# Maule Aircraft Corporation

Service Letter # 9  
Models effected: Bee Dee M-4, M-4 and M-4-210  
Mandatory on Serial Numbers:  
Bee Dee M-4, 3 thru 14  
M-4, 15 thru 94  
M-4-210, 1001 thru 1050  
FAA Approved

Instruction SheetService Letter # 9

FIG. 1  
CONTROL INSTALLATION

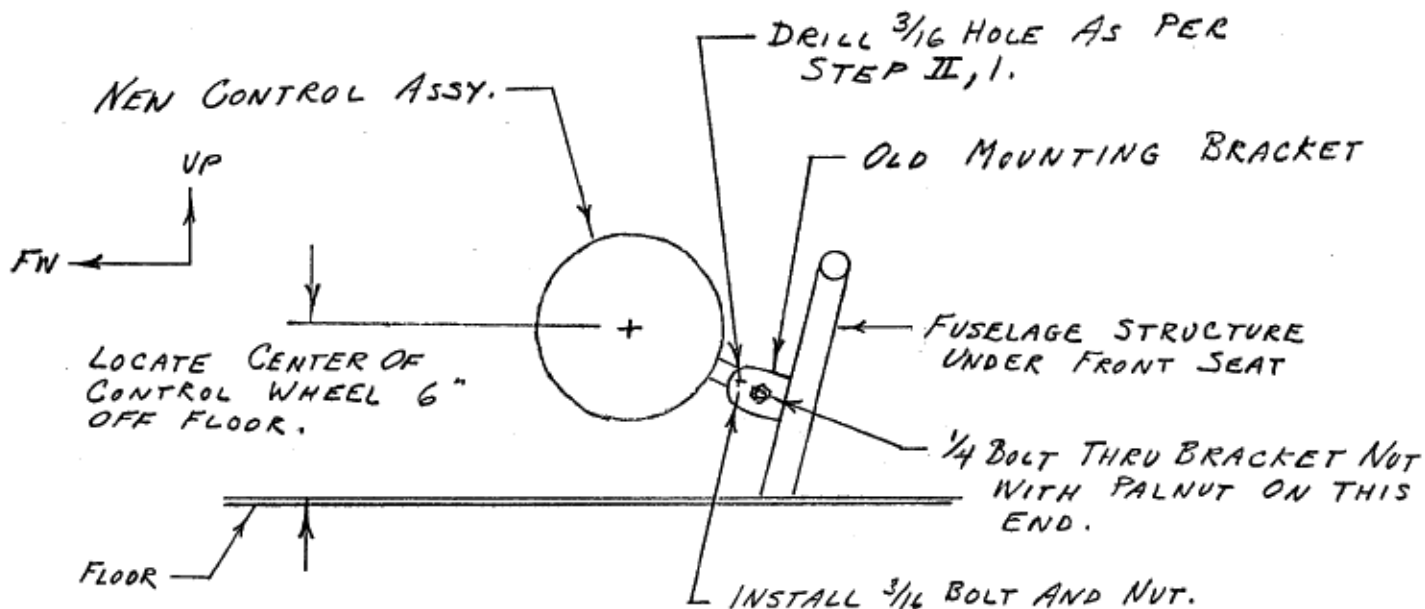
1. Install the new control assembly to the old mounting bracket as shown in Fig. 1, by installing the 1/4" bolt and locating the control 6 inches off the floor and drill 3/16" hole thru the mounting bracket, using the predrilled hole in mounting bar as a locator.

2. Install the 3/16" bolt using the hole drilled in Step 1.
3. Remove the fork ends from the turnbuckles and install the turnbuckle eye ends supplied.
4. Connect the turnbuckles to the new control chains as shown in Fig. 2 using the connector links supplied.

FIG. 2

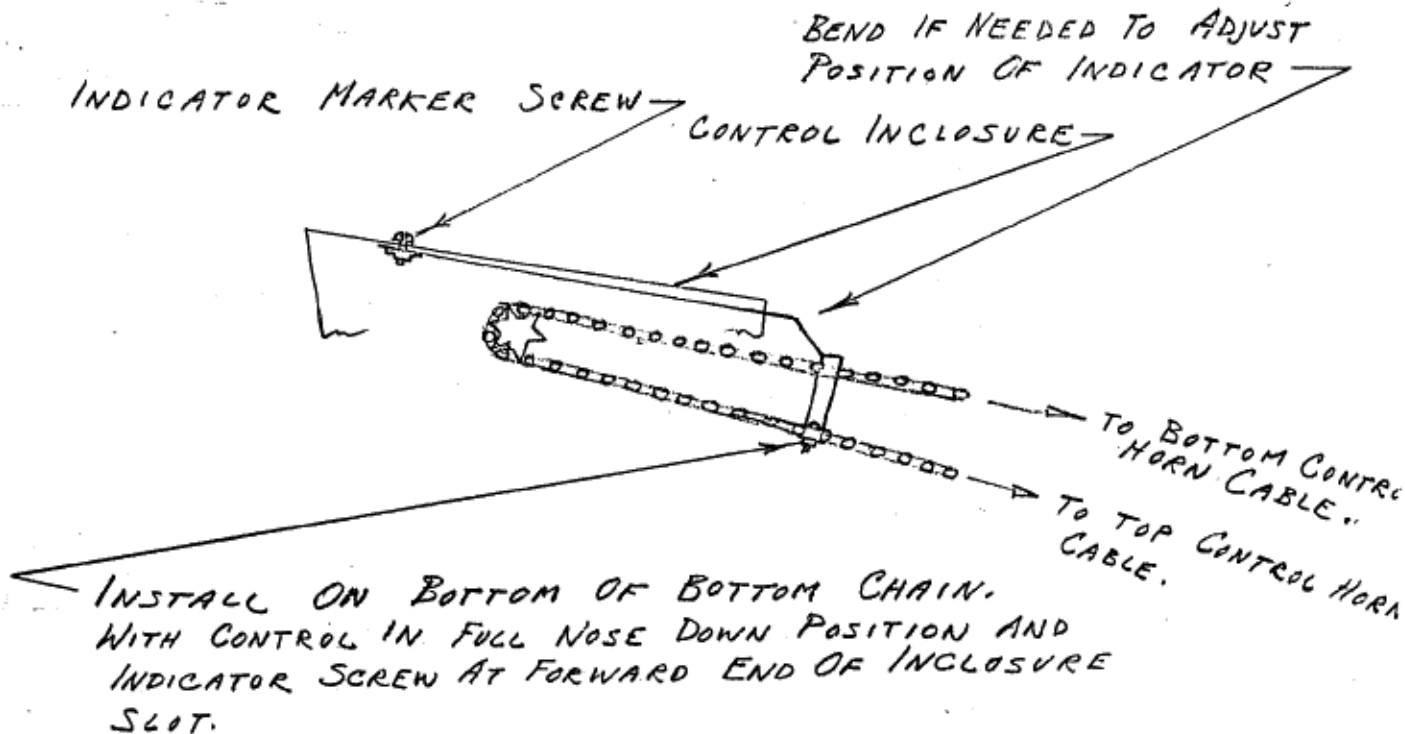
8. Install the tab position indicator as shown on Fig. 2 and check for full travel nose up to nose down stops.
9. Turn control wheel to  $0^{\circ}$  tab angle and install placard supplied so that the take-off marking is opposite the indicator marker.
